**PLANNED UNIT DEVELOPMENT
STAFF REPORT****Date: October 17, 2013****DEVELOPMENT NAME**

Westwood Plaza, LLC

LOCATION7765 Airport Boulevard
(Southeast corner of Airport Boulevard and Schillinger Road South, extending to the North side of Thomas Road)**CITY COUNCIL
DISTRICT**

Planned Unit Development Approval to amend a previously approved Planned Unit Development to allow shared access across multiple lots and multiple buildings on a single building site.

SITE PLAN

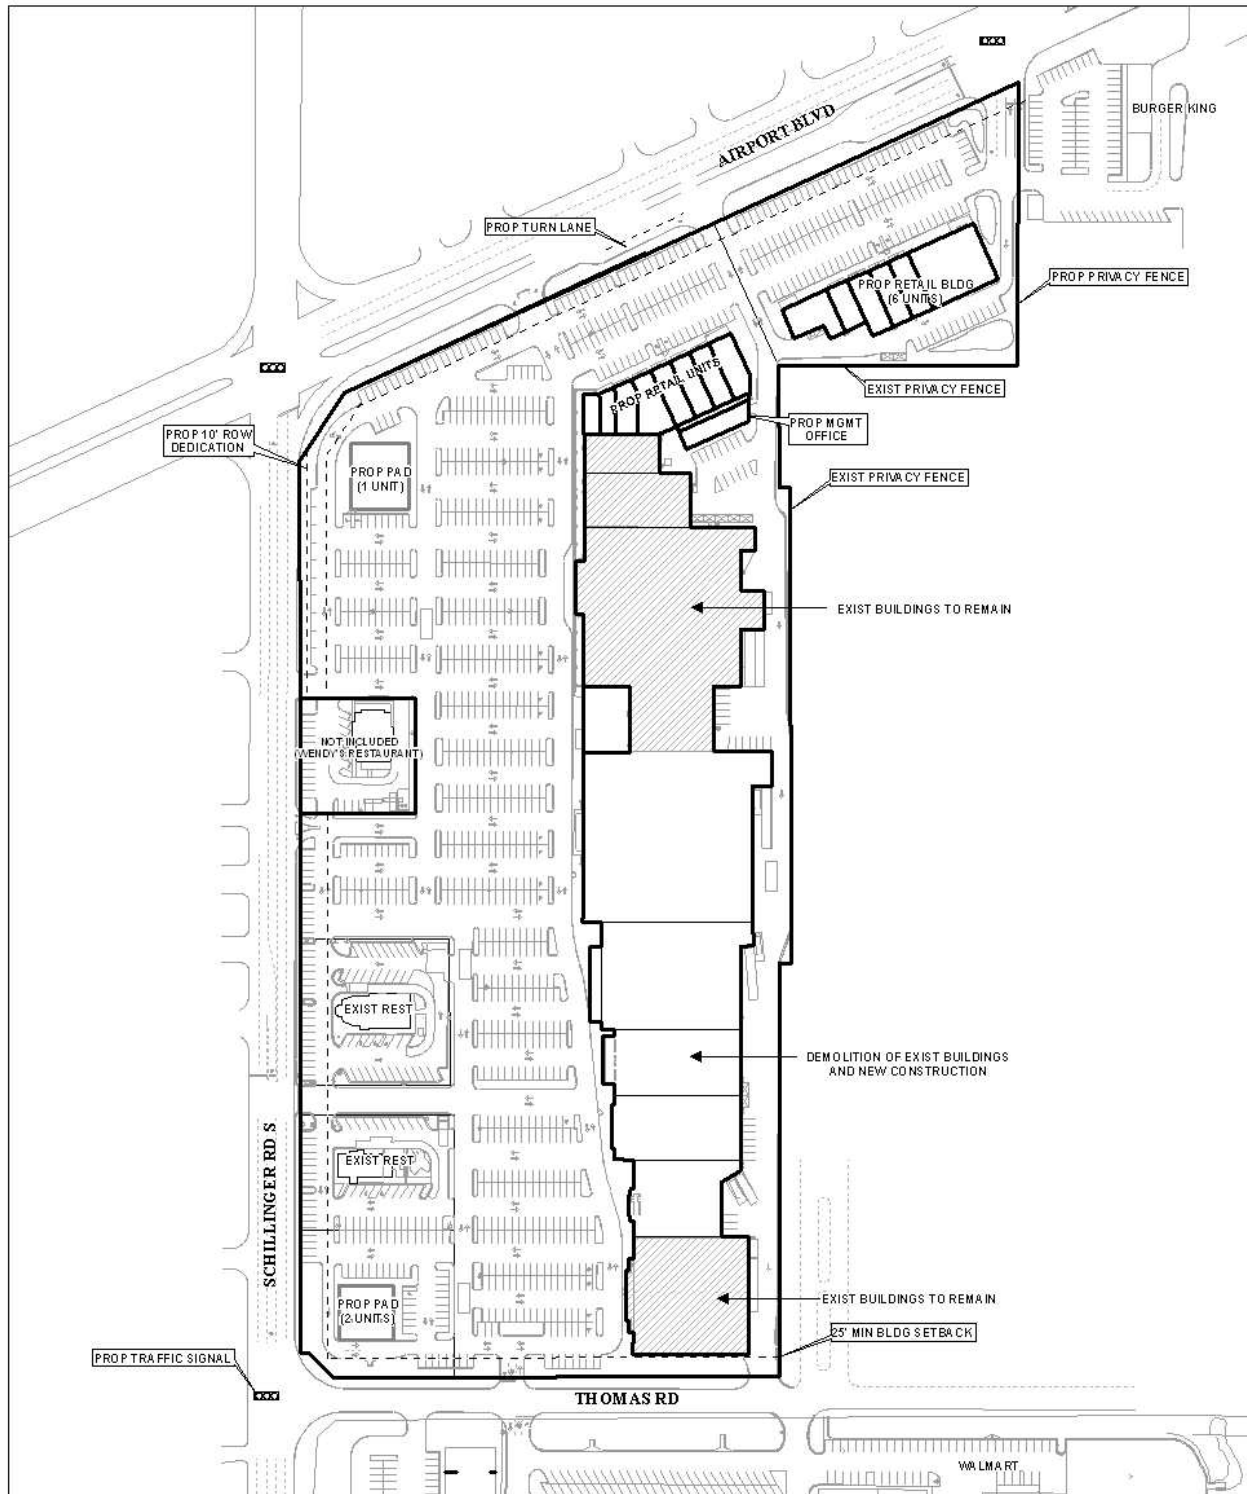
The stated purpose of this application is to add a third curb-cut for the site, which will be substantially redeveloped, to Schillinger Road. Review of the site plan by staff shows, however, that the proposed building footprint area will be increased by 752 square feet over the previously approved PUD, that the landscape area will be reduced by at least 320 square feet, and that parking spaces will be lost due to the requested curb-cut, and a shift in access aisles between the Wendy's and the Chick-fil-A restaurants.

With the requested changes, the proposed redevelopment of the site (*according to the information provided on the site plan, as no narrative was provided*) will result in a combined building footprint of 266,192 square feet, and 1,145 parking spaces, versus the previously approved PUD of 265,440 square feet and 1,149 parking spaces. As a reminder, the site has an existing strip center that will be redeveloped and expanded and two existing developed out parcels. It should be pointed out that staff added the parking numbers provided on the site plan by row, and determined that the revised site plan may only depict 1,133 parking spaces, instead of the 1,145 parking spaces listed, thus resulting in a loss of 16 parking spaces from the previous approval: if the number of parking spaces labeled on the plan is inaccurate, the plan should be revised to accurately reflect what is depicted on the site plan.

A Traffic Impact Study submitted by the applicant with the previous application recommended that the access point just south of the existing Wendy's restaurant be closed, and the previously approved PUD reflects this recommendation. The applicant now wishes to reintroduce the curb-cut at this location, but as a right-in, right-out only access, versus the now existing full access curb-cut.

The requested curb-cut will reduce the total landscape area and frontage landscape area for the site. Other modifications to the site plan will additionally reduce the total landscape area for the site. The previously approved PUD was 31,355 square feet short of the 113,627 square feet of required landscape area, thus the deficit will be slightly increased by the proposal at hand. Furthermore, the new curb-cut appears to eliminate one of the proposed frontage trees, however, no tree and landscape plan was submitted with the PUD application, so staff cannot determine if the site will provide the previously approved number of frontage trees or total trees for the site.

A note on the site plan states that a Sidewalk Waiver will be requested along both Airport Boulevard and Schillinger Road, however, an application was not included for consideration with the application. A Sidewalk Waiver application should be submitted prior to any request for permits related to new construction.

- 1) Revision of the site plan to accurately list the total number of parking spaces proposed, including the Chick-fil-A and Krystal sites;
- 2) No increase in building area or change in parking ratios allowed without a new PUD application;

- 7) *No reduction in the proposed total and frontage landscape area depicted on the site plan submitted for the October 17, 2013 meeting;*
- 8) *No reduction in the proposed number or overstory/understory mix of total and frontage trees, as depicted on the tree and landscape plan approved at the August 8, 2013 Planning Commission meeting;*

- 11) *Full compliance with all other municipal codes and ordinances, including the provision of a sidewalk along all street frontages, or the submission of a Sidewalk Waiver request prior to any request for new construction permits.*
